Boulder County

BOULDER COUNTY BOARD OF REVIEW
A G E N D A

4. **BORC-15-0001: 2015 INTERNATIONAL CODES ADOPTION & AMENDMENTS, AND PROPOSED BOCC RESOLUTION 2015-104**

On September 22, 2015, the Boulder County Board of Review met for a public hearing and to t**ake action and make a formal recommendation to the Board of County Commissioners on the 2015 Updates and Amendments to the Boulder County Building Code, as contained in proposed BOCC Resolution 2015-104.**

FIGURE R327.2
WILDFIRE ZONE MAP

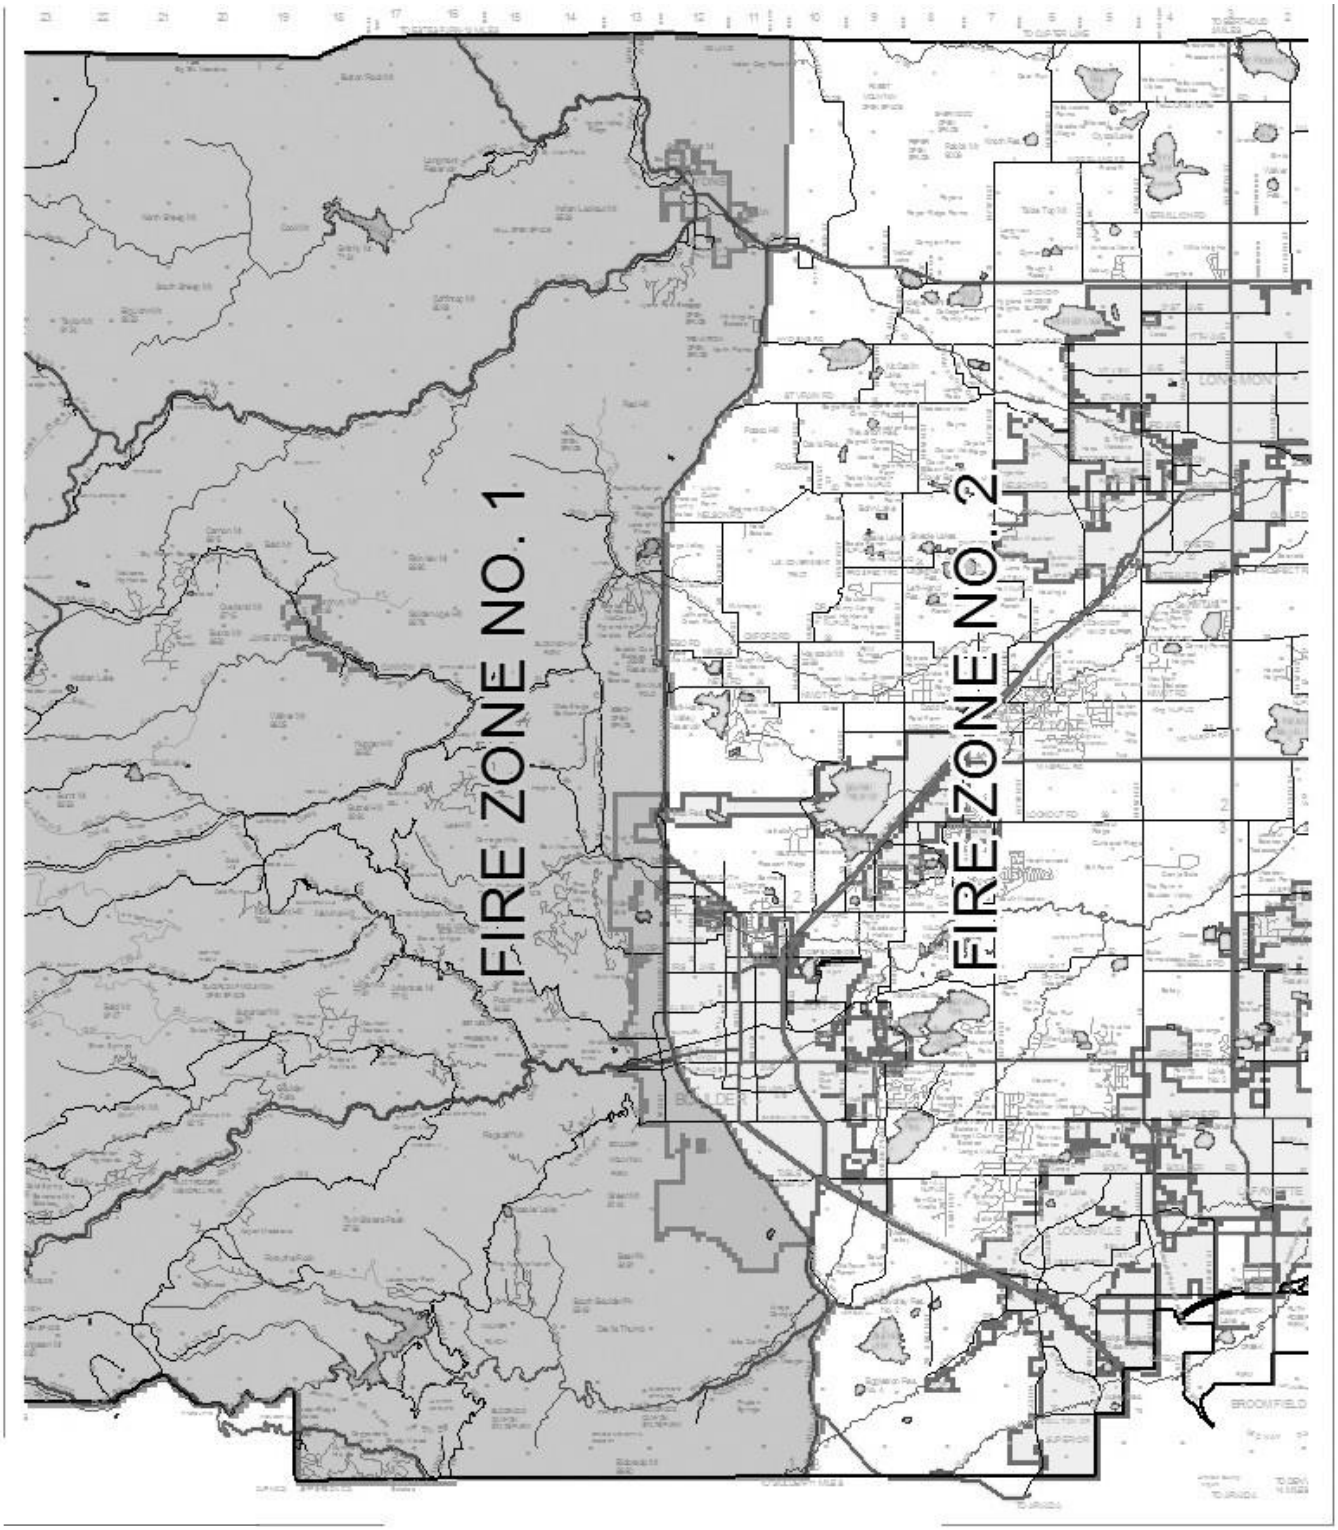
~~R325.2~~ R327.2 Wildfire Zones Defined. For the purpose of this code, the unincorporated portion of Boulder County is divided into wildfire zones, which shall be known and designated as Wildfire Zone 1 and Wildfire Zone 2. The wildfire zones shall include such territory or portions of the unincorporated county as shown in Figure ~~No. 1~~ R327.2, the Wildfire Zone Map~~, which is attached to and incorporated into this section by this reference.~~

TABLE N1106.4
MAXIMUM ENERGY RATING INDEX

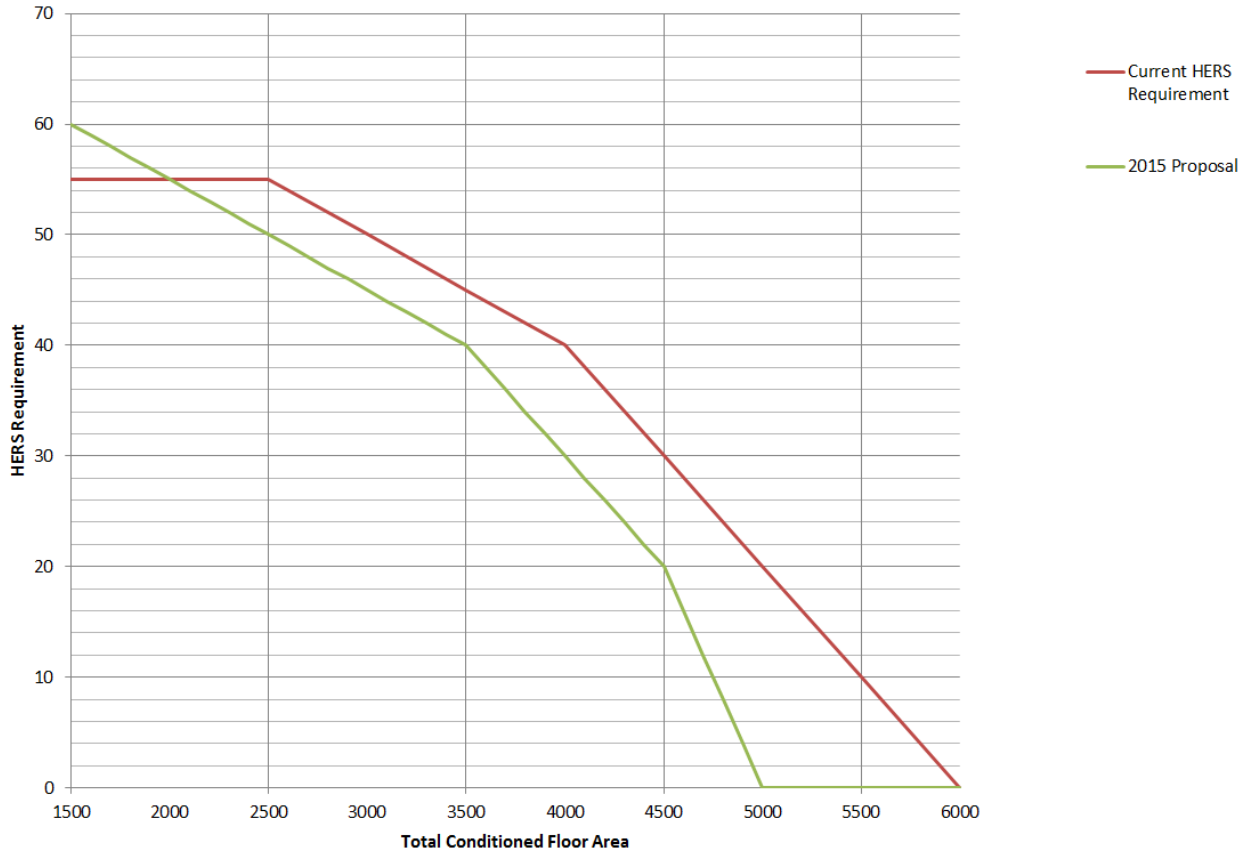
Proposed footnote: "For thick wall assemblies such as double-stud and strawbale walls, for the purpose of determining HERS requirements (Table 1), conditioned floor area calculations shall be measured from the interior air barrier as depicted in the construction documents." {commentary: The intention is to encourage low embodied energy construction materials such as cellulose and straw by avoiding penalizing of their relatively low r-values per inch.}
